ULNRC-05178

DOCKET NUMBER 50-483
UNION ELECTRIC COMPANY
CALLAWAY PLANT

TECHNICAL SPECIFICATION REVISIONS ASSOCIATED WITH THE
STEAM GENERATOR REPLACEMENT PROJECT

FIGURE 2.2-1 Maximum Allowed PORV Setpoint for the Cold Overpressure Mitigation System

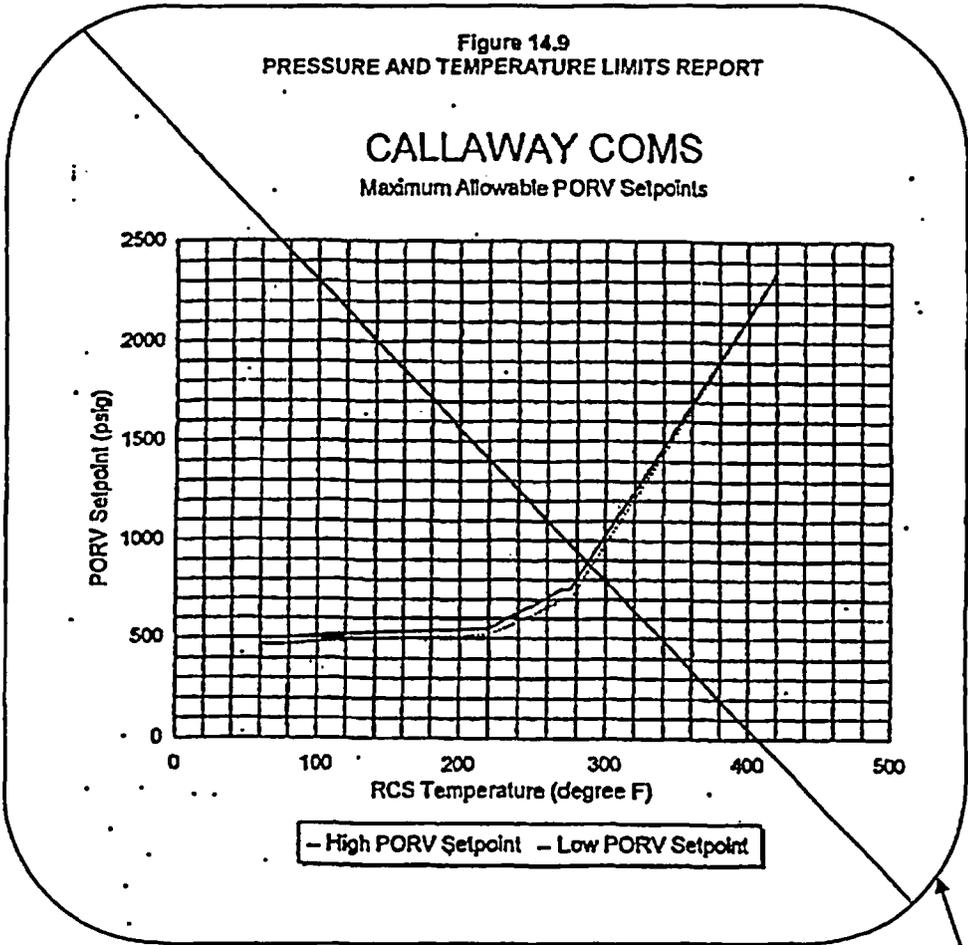
The statements made in Section 4.3.5 of Appendix A to Reference 1 and in the response to Question 11 in Reference 5 were predicated on an assumption by Westinghouse that AmerenUE would limit the operation of reactor coolant pumps (RCPs) below a reactor coolant system (RCS) temperature of 200°F such that a maximum of two (2) RCPs would be allowed to operate whenever the RCS temperature was $\leq 200^\circ\text{F}$. AmerenUE has decided to implement Cold Overpressure Mitigation System (COMS) setpoints that have no RCP operation restrictions. These COMS setpoints are more limiting than their counterparts that have RCP operation restrictions, but will not present any undue burdens on plant operation. Since these COMS setpoints are more limiting than those currently presented in the PTLR, the PTLR will be revised and the COMS setpoints will be changed to implement the RSG project. The attachment to this letter shows the draft PTLR changes, which provide the new calculated values for RSG as well as the current maximum allowable PORV setpoints. The current COMS setpoints have not been revised since the initial PTLR submittal to NRC in Reference 7.

See
Insert 2

INSERT 2
FIGURE 14.9

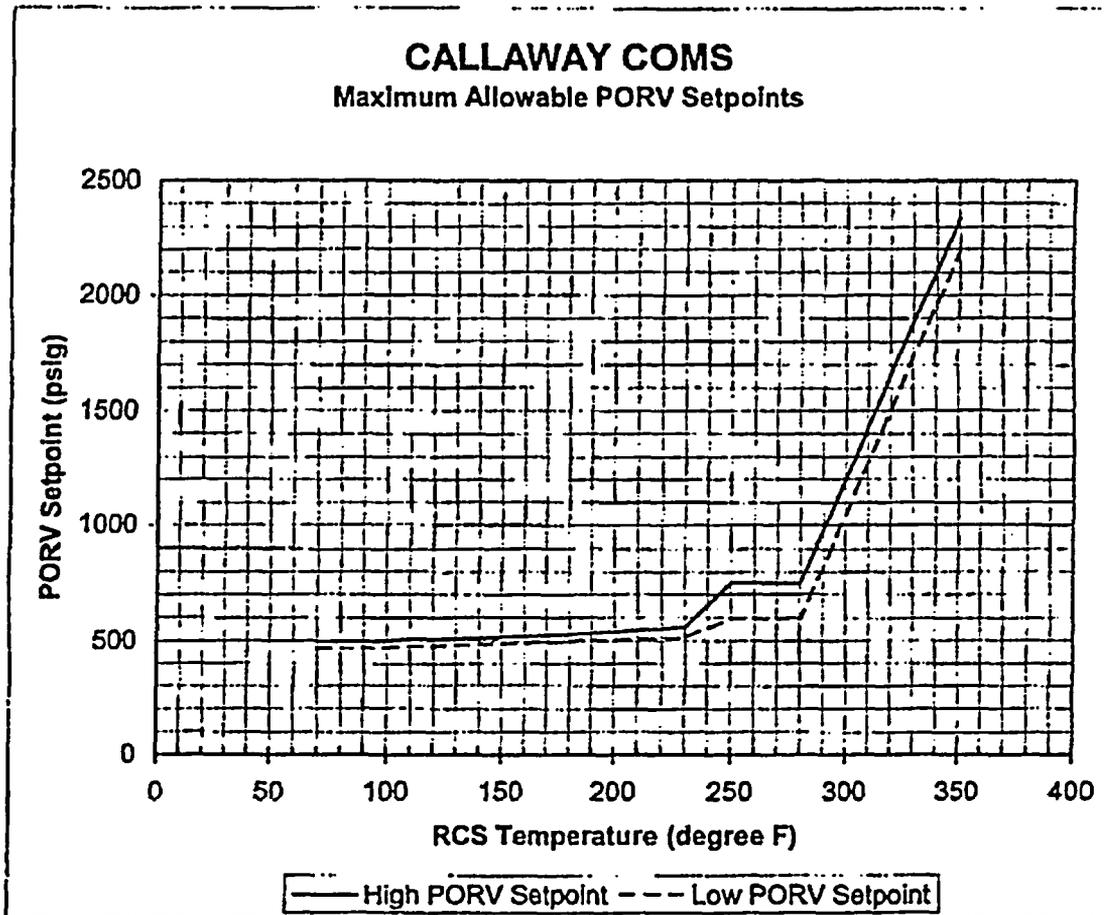
all 4 or less RCPs are in operation

Temperature - RCS (°F)	High Setpoint (psig)	Low Setpoint (psig)
70	496	466
80	496	466
90	496	466
180	527	497
230	558	512
250	750	597
270	750	597
280	750	597
350	2335	2185
